## CITY of NOVI CITY COUNCIL

Agenda Item 3  
December 7, 2009

**SUBJECT:** Consideration of the request of Novi Town Center Investors, LLC, for Preliminary Site approval for Building I, located on the south side of Crescent Boulevard, east of Ingersol Drive in the Novi Town Center development. The applicant is proposing to renovate and demolish portions of the existing Building I, add parking immediately adjacent to the north side of the building, move the loading and dumpster area, and complete interior renovations to reconfigure lease spaces.

# Novi Town Center Building I Demo and Reconstruction SP 09-23

**SUPPLEMENTAL PLAN TO  
ADDRESS TRAFFIC CONSULTANT'S CONCERNS**

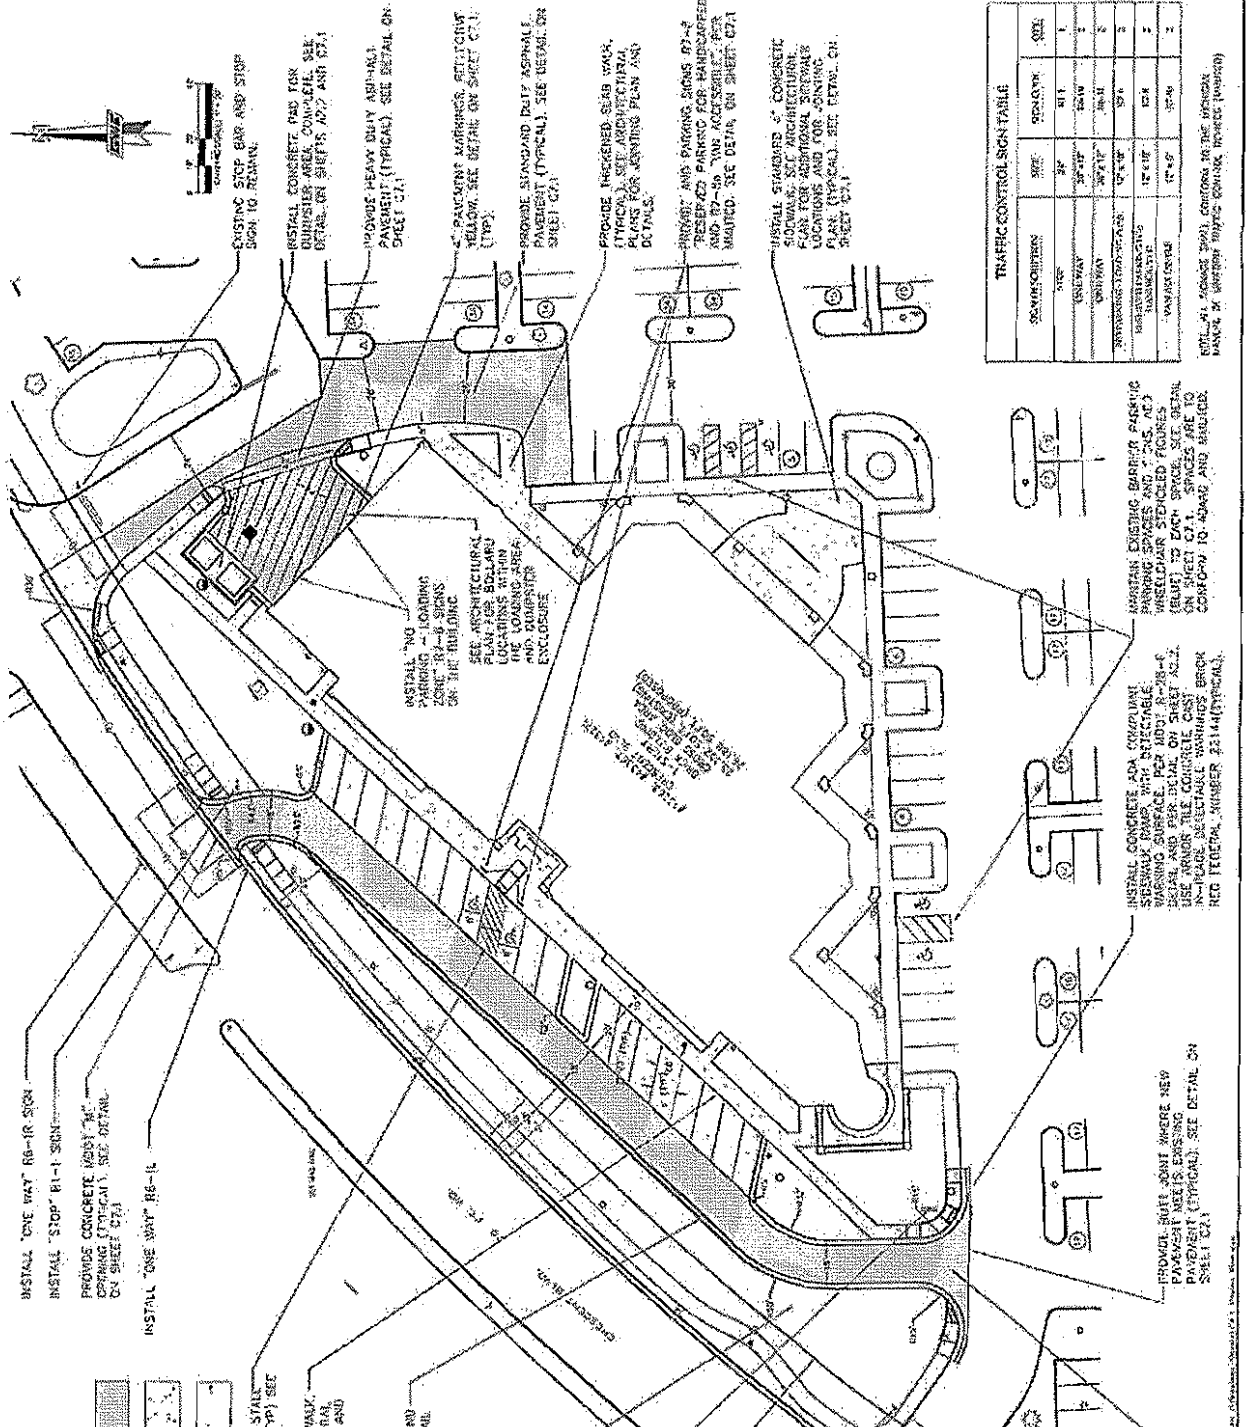
The Traffic Review noted a number of deficiencies with the plan, however, the applicant and the City's Traffic Consultant have worked together to resolve these issues. The applicant has submitted a supplemental plan and the changes to the entryway will be incorporated into the stamping set submittal. A same-side driveway spacing waiver is required for the new access point on Crescent Boulevard.

1. A new point of access is proposed on Crescent Boulevard, a 25-mph non-residential collector under City jurisdiction. This proposed access is an exit-only one-way drive from the new eastbound flow-through parking lot along the north side of Building I. **The same-side spacing between this drive and the next drive to the northeast is dimensioned on Sheet C4.1 as 89 ft (near-back to near-back of curb), or less than the 105 ft minimum required by the City's Design and Construction Standards (DCS Sec. 11-216(d)(1)d). A waiver must be sought and received from the Planning Commission, and Birchler Arroyo recommends the Planning Commission grant said waiver.** Relocating the new driveway any further southwest in order to meet driveway spacing standards might encourage traffic exiting that new driveway to cut diagonally across north-eastbound Crescent Boulevard to access the nearby turnaround in the median. It is worth noting that the proposed spacing between the driveways was reduced from 98 feet to 89 feet (thereby requiring a longer waiver) to accommodate design changes recommended by Birchler Arroyo (see Comment 2 of our October 30, 2009 letter for details).

3. The proposed new one-way driveway is 18 feet wide (measured back-to-back of curb), 2 feet wider than the City standard of 16 feet (per DCS Fig. IX.2). The applicant has in our opinion "shown cause" for the wider driveway, consistent with the standards of DCS Fig. IX.2. See our October 30, 2009 for further detail.

The final site plan has been revised per the comments and recommendations of our review letter dated October 30, 2009 (attached). Birchler Arroyo recommends final site plan approval, contingent upon the Planning Commission granting a waiver for driveway spacing as discussed in Comment 1 below. Birchler Arroyo recommends the granting of that waiver.

Photo No. 1

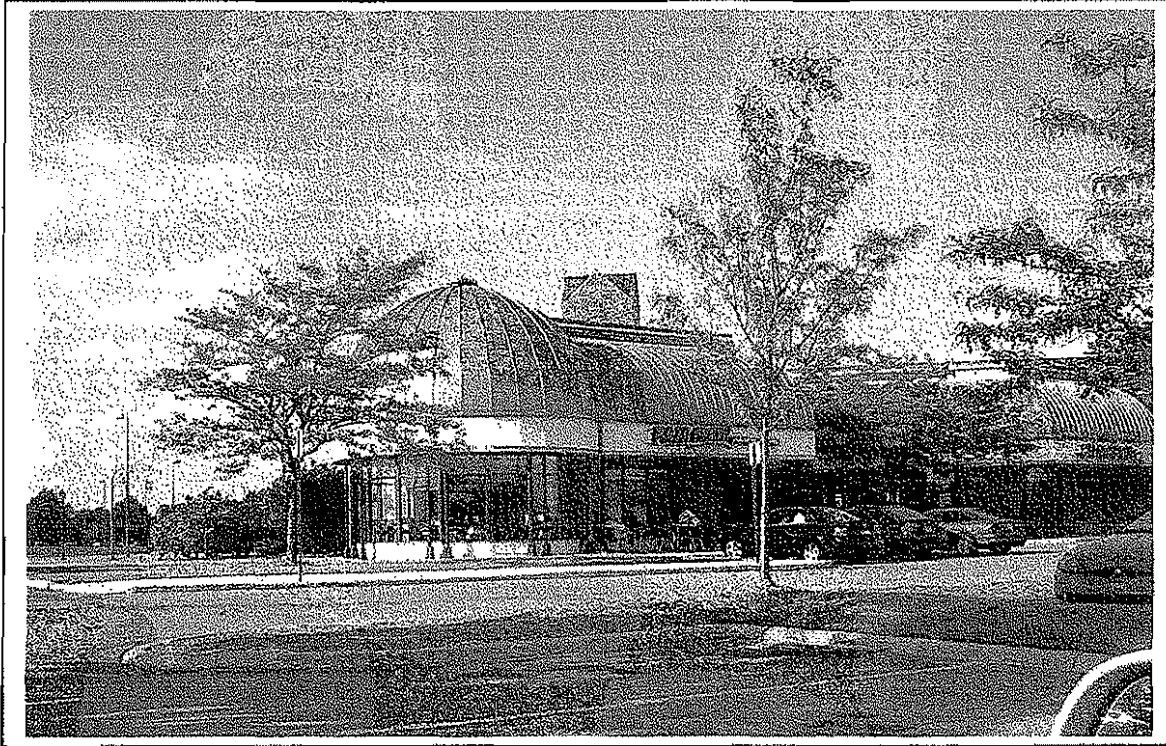
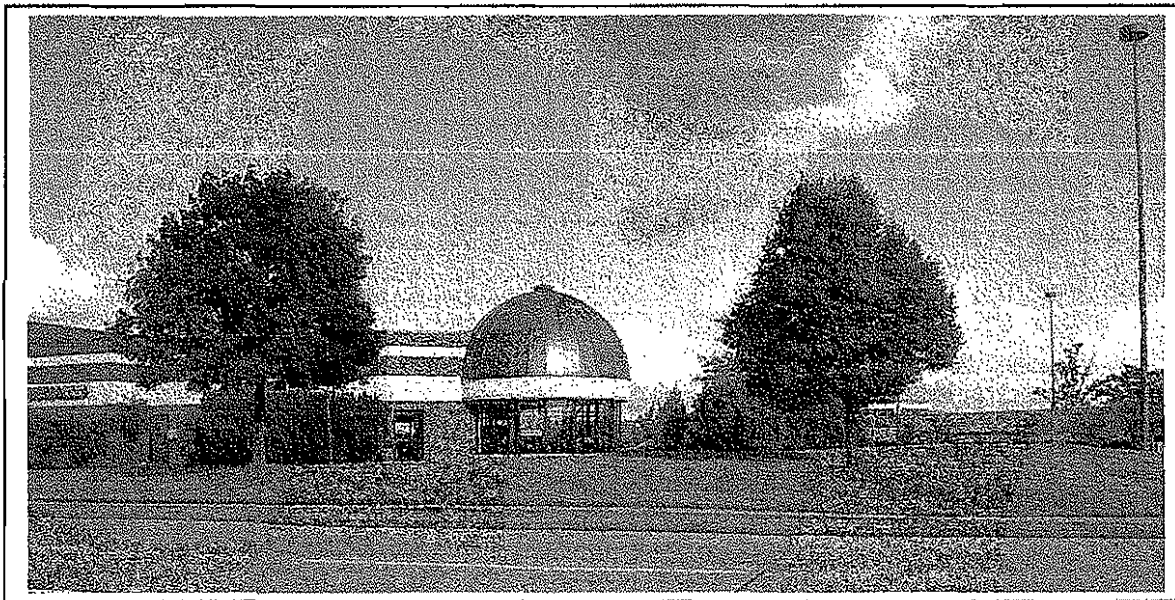
With this submittal the applicant has revised the design to address the above as well as other points raised in our previous review. The dome element at the west end of the building has been preserved and will be painted to match other metal roofs. The new facade treatment consisting of brick piers and an EIFS cornices has been introduced wrapping around the base of the dome. This creative solution will serve to visually tie the dome into the new facade while preserving the dome as a landmark visual element. The east dome has been eliminated however this is consistent with the overall design given that the dumpster and service delivery area has been relocated to that location. The elimination of the central dome on the south facade is acceptable given that a nicely designed pediment has been introduced in its place. The pediment actually harmonizes more readily with the clock tower beyond than the original domed element. The clock tower (Photo No. 3) has been preserved and its existing standing seam roof will be painted to match other roofs. Overall the unique identity of the building has been preserved and the building will continue to serve as the signature building of the Novi Town Center.

With respect to the use of non-copper colored roofs the proposed materials are consistent with other recent facade upgrades for which the Planning Commission has granted Section 9 waivers for the use of green, blue and black standing seam metal. The Cement Plaster is an existing material and the comparatively small percentages are not inconsistent with the overall design of the building. The proposed design complies with the Town Center Ordinances requirement that building be constructed primarily of Brick and Stone.

**Recommendation** - It is our recommendation that the proposed design is consistent with the intent and purpose of the Section 2520, the Facade Ordinance and Section 1600, the Town Center Ordinance. Therefore, a waiver of the specific requirements of the Facade Chart as described in Section 2520.9 (Section 9 Waiver) is recommended for the use of non-copper colored Standing Seam Metal, the overages of Cement Plaster and Standing Seam Metal, and the underage of Brick on the west facade.
